COMMENTS & CONDITIONS MEMO

Subject: **REQUIREMENTS FOR RESIDENTIAL DEVELOPMENT**
Application to Amend the Official Plan and Zoning By-law
Amendment and Proposed Draft Plan of Subdivision
 (To permit Residential and Office uses)
 Updated Comments from Parks & Facility Planning and Open Space
 Development Sections

Location: 8863 The Gore Road
 Part of Lot 4, Concession 10, Southern Division
 Circulation Date: September 11, 2017
 Ward: 8

Subject: **COMMUNITY DESIGN GUIDELINES**
 2nd Submission
 Application to Amend the Official Plan and Zoning By-Law and Proposed
 Draft Plan of Subdivision
 (To permit *residential and office uses*)
 Updated Comments from Parks & Facility Planning and Open Space
 Development Sections

- 16. Pp 30 – Figure 15

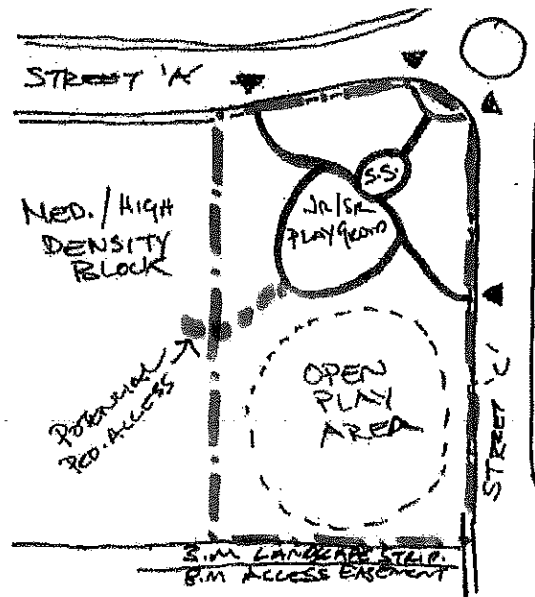
All street-related active transportation components depicted in the Active Transportation and Circulation scheme depicted in this figure needs to be reviewed and confirmed with Traffic Operations and Transportation Planning, prior to draft plan approval.

- 17. Pp. 30, Section 4.1.13 - Figure 15
 - 17.1. Please show the conceptual public-private connection point at the south west corner of the Employment block transition to the ROW.
 - 17.2. Correct the spelling of "connections".
 - 17.3. Remove the "*" from "*conceptual trail connection*".
